AES-O-NRC-09-01234-0

AREVA Enrichment Services LLC
Eagle Rock Enrichment Facility
NRC Docket No: 70-7015

Subject: Response to Requests for Additional Information – AREVA Enrichment Services LLC Environmental Report for the Eagle Rock Enrichment Facility

Figure 2: One-line diagram showing the proposed transmission system from Bonneville to Antelope and the new interconnect to AREVA substation.

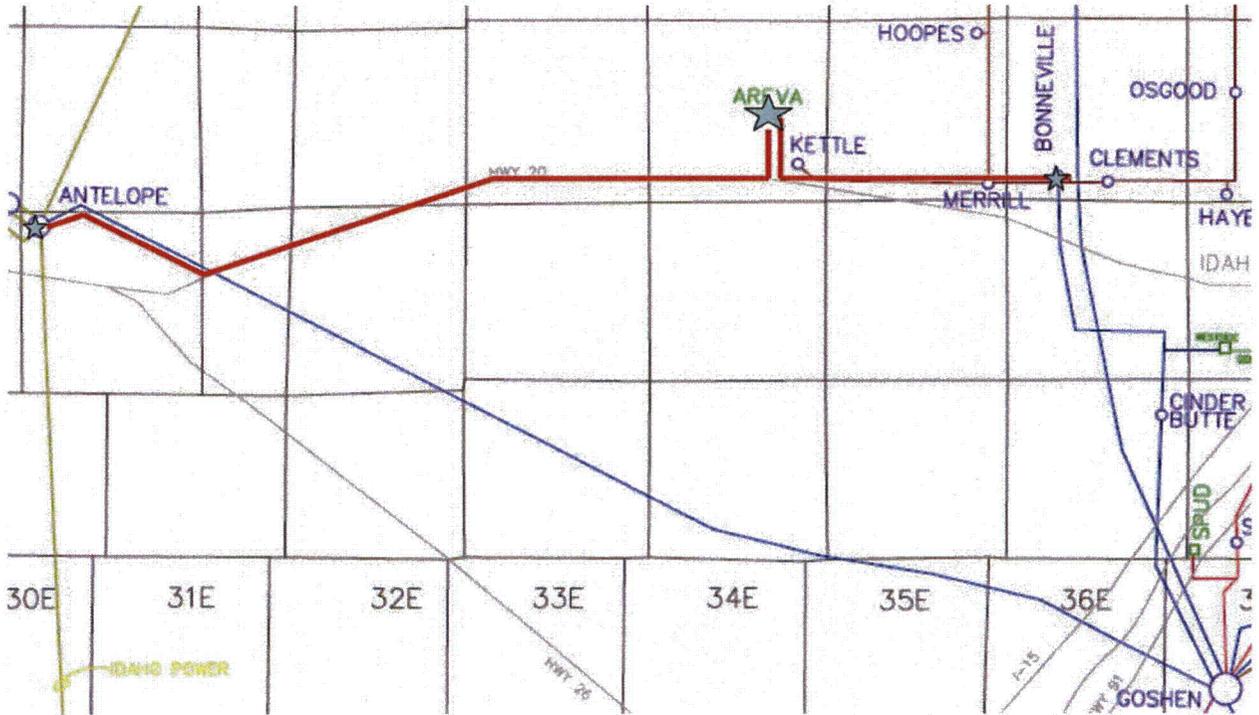
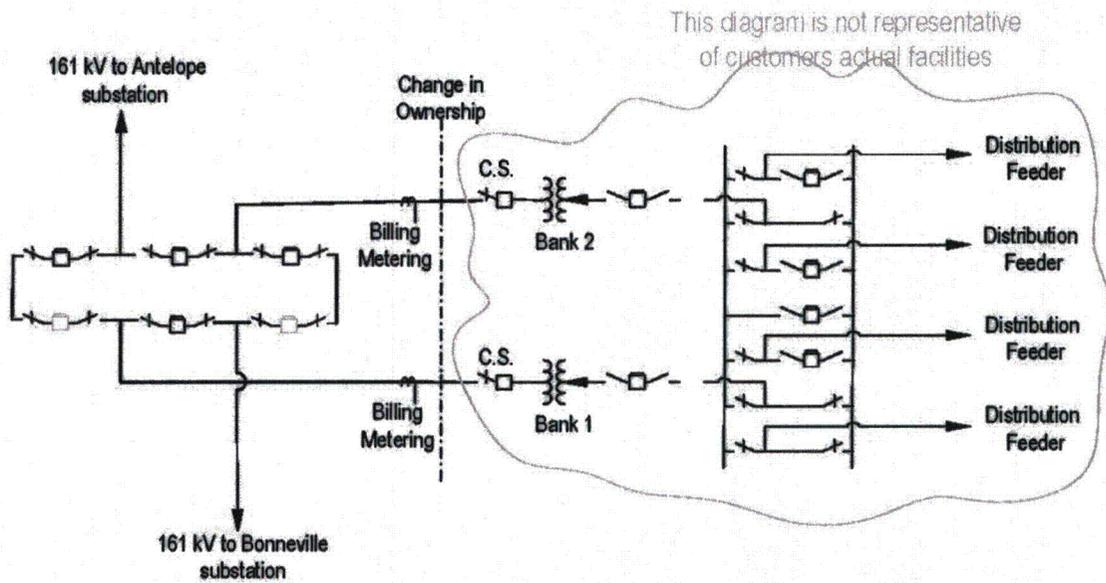
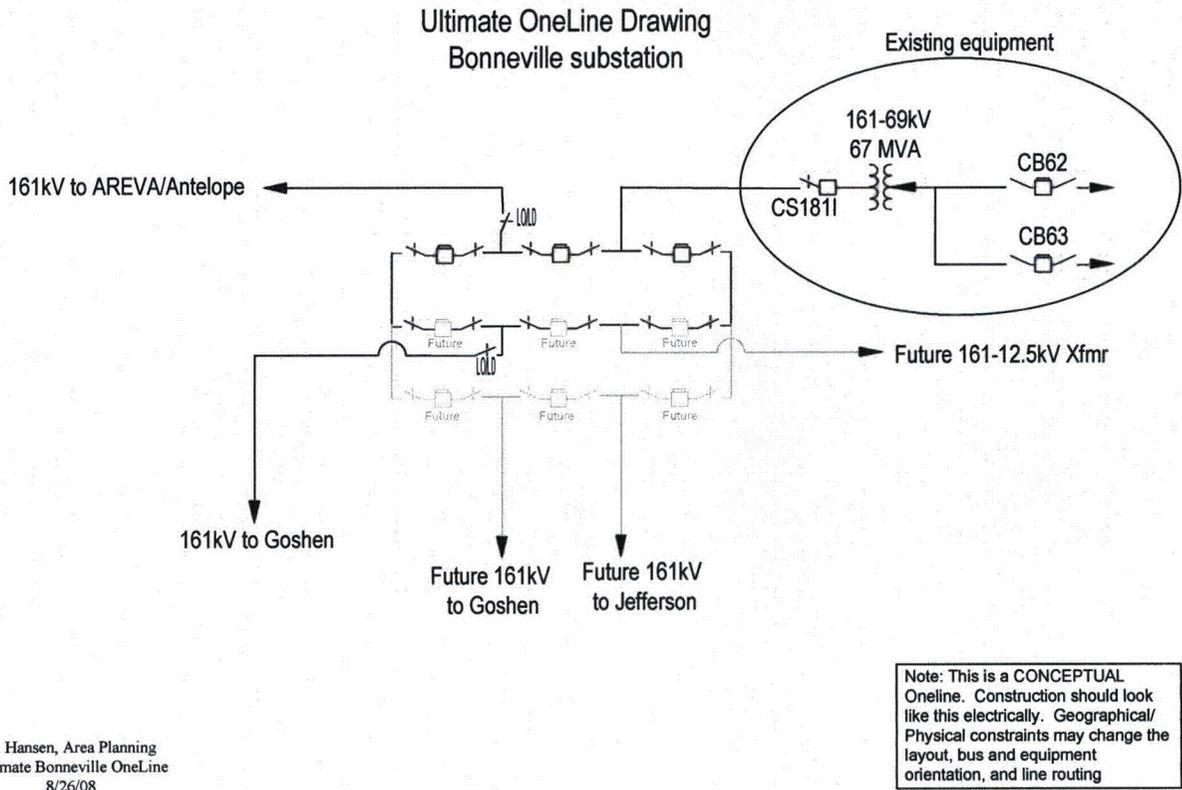
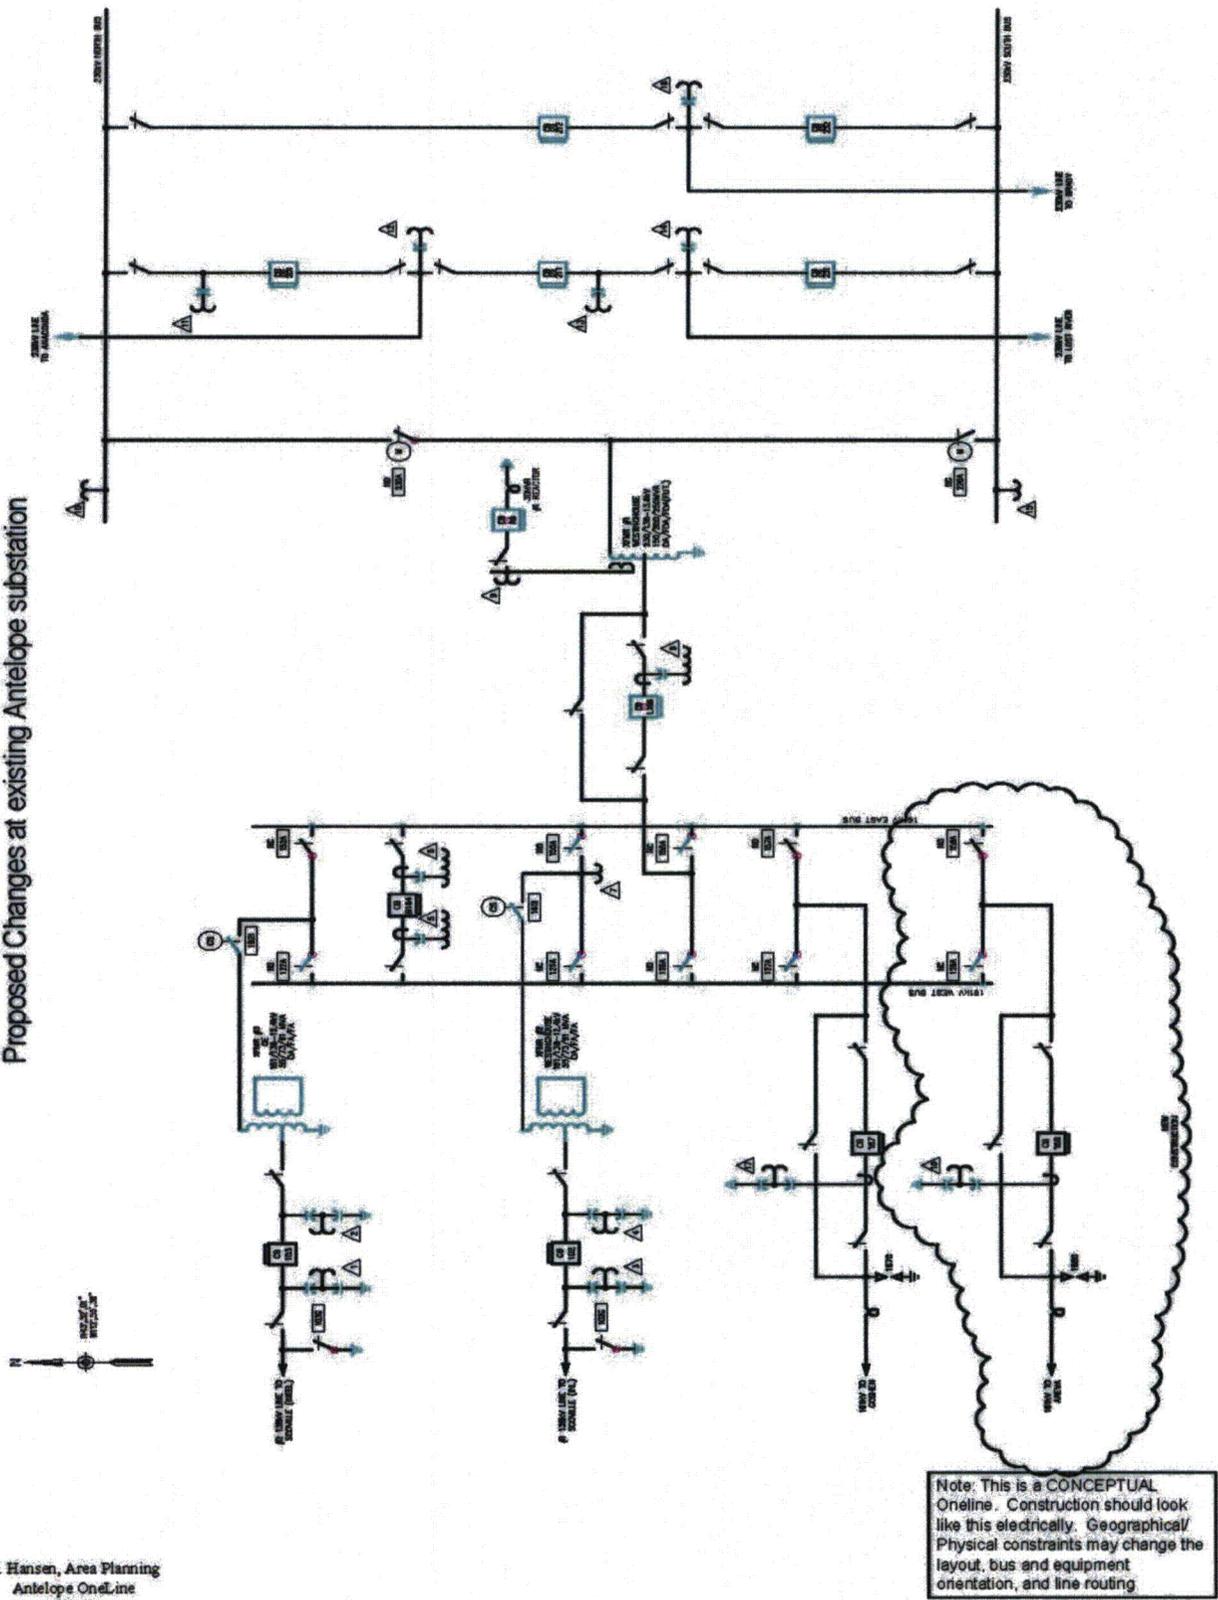
Provide additional information regarding the analysis performed to locate the proposed electrical transmission lines for EREF site power consumption.

- a. Provide a copy of the Rocky Mountain Power conceptual study report (December 2008) that describes potential facility access to the electric grid (transmission line options) as identified during the NRC site visit in June.

Section 4.1.2 (AES 2009a) described land use considerations, but did not provide a basis for the locations of the proposed transmission lines. This information is needed to assess the construction and operation cumulative impacts of the proposed EREF.

Comparison of Water Usage Construction vs. Operations

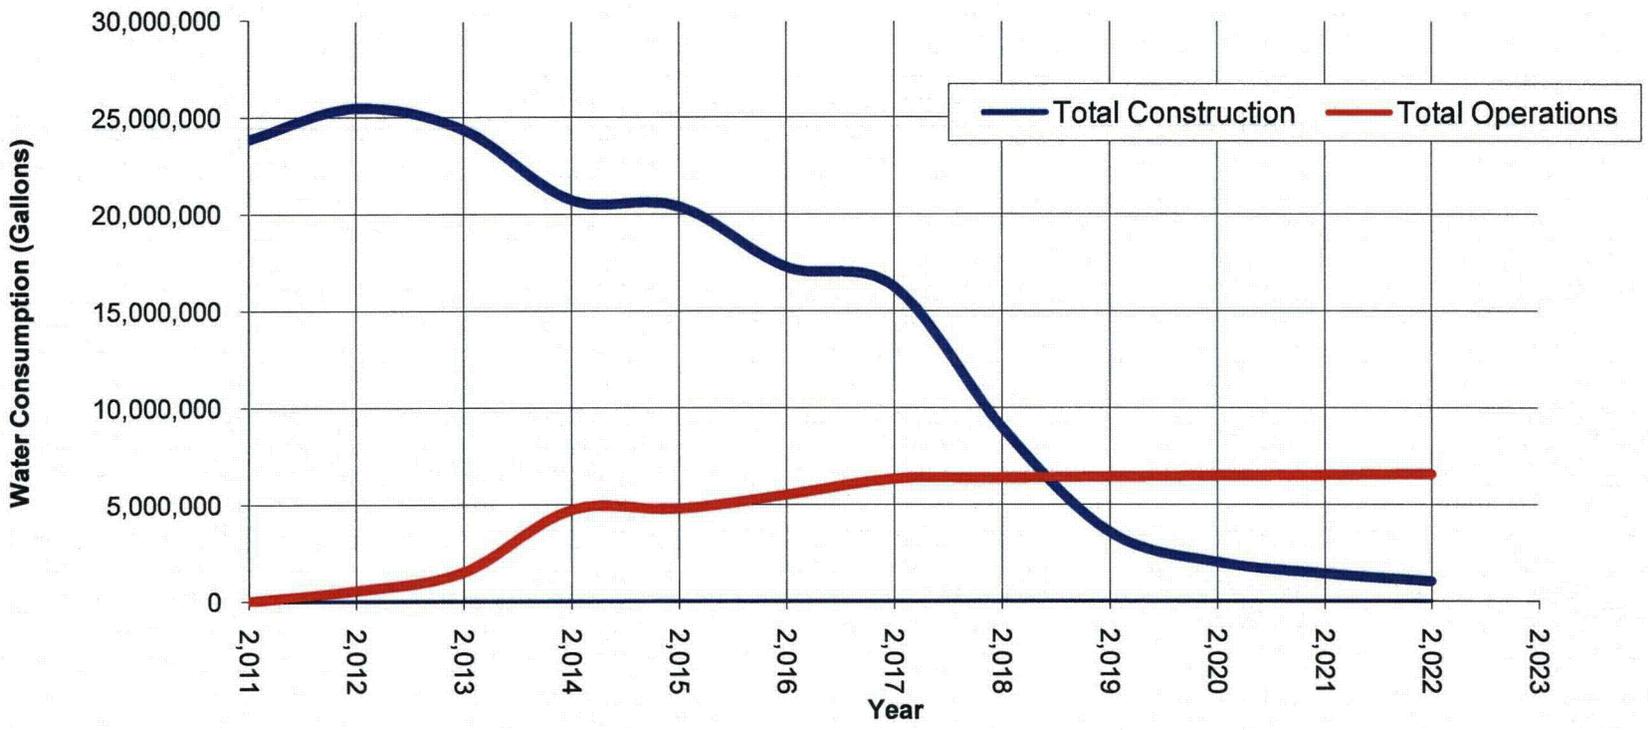
- a. Identify the year in which water usage for construction and operations become additive.
- b. Clarify the point during the 7 -year heavy construction period in which the process (makeup water) and fire protection water demand values under operations are added to the construction values. Provide a graphic that depicts the change in water demand usage between construction and operation.

A graph depicting the change in water demand usage between construction and operation for the period beginning with the start of construction (February 2011) and ending with full facility production (March 2022) is provided in Enclosure 3.4.

Figure 1: EREF SBM GEVS ("A") and TSB GEVS ("B") Release Points and Receptor Locations 1-10

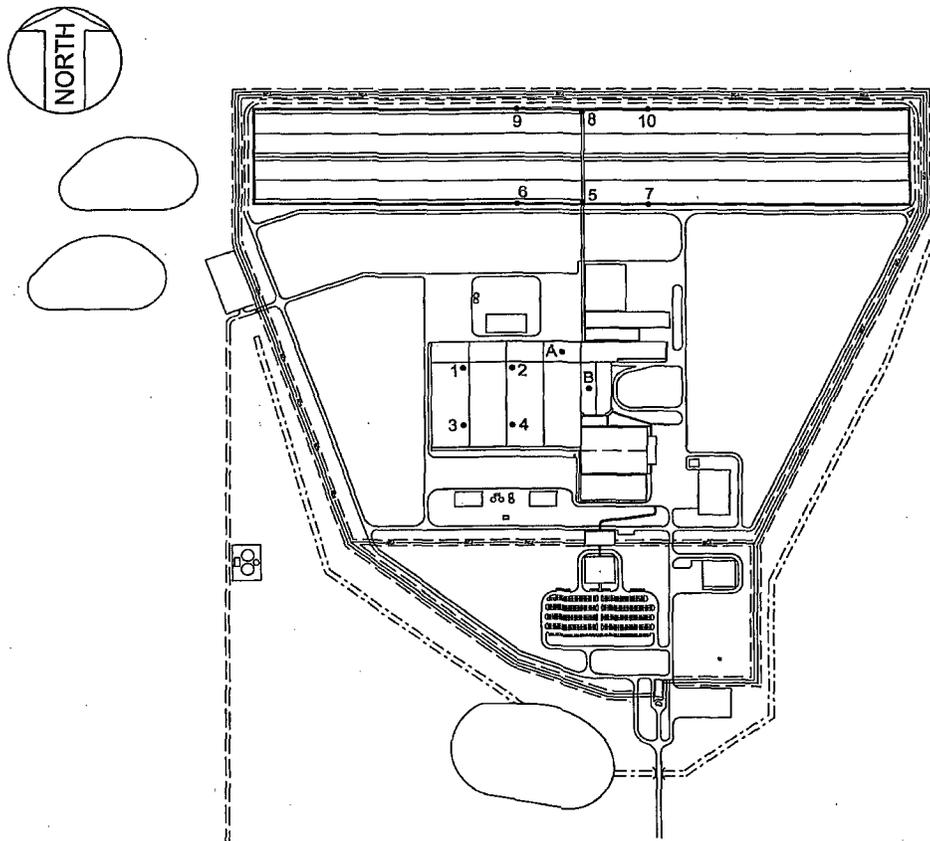
Provide additional information regarding on-site workers and facility structures.

- a. Provide an approximate population distribution of on-site workers during the period of time after enrichment operations have commenced and construction continues on the remainder of the facility.
- b. Supply building location, heights and respective stack heights for all uranium emission release points.

Information on building heights and/or stack heights where emissions would occur is needed to perform confirmatory radiological and chemical air dispersion analysis, as considered in Section 4.12.2 (AES 2009a). Provide location and height of all emission release points (i.e. stack or ground release).

The center point of construction worker activities has been assumed to focus around ten selected receptor locations as shown on Figure 1 of Enclosure 3.5. For construction work that involves the build-out of the UF₆ Handling Areas, two locations at the corners of the inner and outer UF₆ Handling Areas (receptor locations 1 and 2) are taken as representing the average receptor for work time activities in that portion of the plant. For the build-out of the SBMs, two additional center points at the southern corners of the SBMs are included (receptor locations 3 and 4), making a total of four receptor centers over which construction time is evaluated and averaged for impacts to workers assigned to the SBM construction. A total of six receptor center points for gaseous release impacts (receptor locations 5, 6, 7, 8, 9, and 10) are used in

X/Q and D/Q atmospheric dispersion values were determined based on a ground level release. On Figure 1 of Enclosure 3.5, Point A represents the release location for the first SBM GEVS system. Point B represents the release location for the TSB GEVS. Receptor locations 1 and 2 represent the center area for construction activities with the additional UF₆ Handling areas and the northern half of the SBM Halls associated with the build-out of the plant after initial start of plant operations. Receptor locations 3 and 4 represent the southern half of the SBM build-out. For the expansion of the Full Tails, Full Feed, and Empty Cylinder Storage Pad, receptor locations 5, 6, 7, 8, 9 and 10 represent the center portion (closest approach) of the pad area for use in estimating the gaseous impact to construction workers anywhere on the pad. The receptor locations, their distances and directions from the two release points, and the atmospheric dispersion values are shown in Tables 3 and 4 of Enclosure 3.5. Building and stack heights will be determined during detailed design. For the purposes of this analysis, however, gaseous releases were conservatively modeled as ground level releases. For entrainment modeling, the tallest nearby building height was assumed to be 15 meters, with an effective cross sectional area of 457.5 m².

For the 10 receptors shown in Figure 1 of Enclosure 3.5 and discussed above, maximum individual doses were calculated for each exposure pathway resulting from the SBM GEVS and TSB GEVS gas releases. These values were added and the sums are shown in Table 5 of Enclosure 3.5.
